SIB 34 07 24

**RECALL 24V-739: INTEGRATED BRAKE SYSTEM (IB)**

This Service Information Bulletin (Revision 3) replaces SI B34 07 24 **dated November 2024**.

**“Wet” IB pre-filled:** Brake fluid reservoir is filled (arrow) and brake fluid line ports are plugged with bolts (circled).

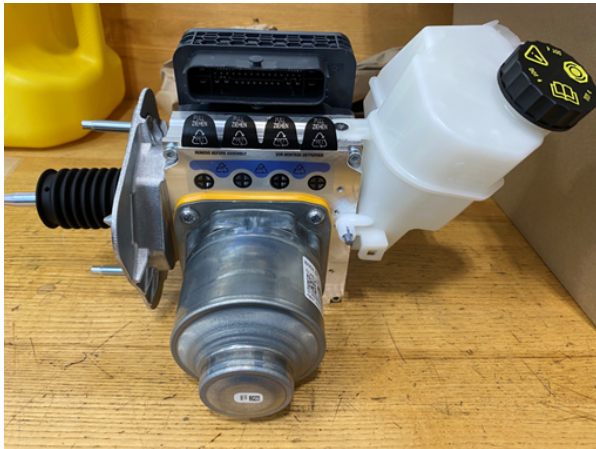
Replace the IB with either a “wet” pre-filled unit or a “dry” unfilled unit.
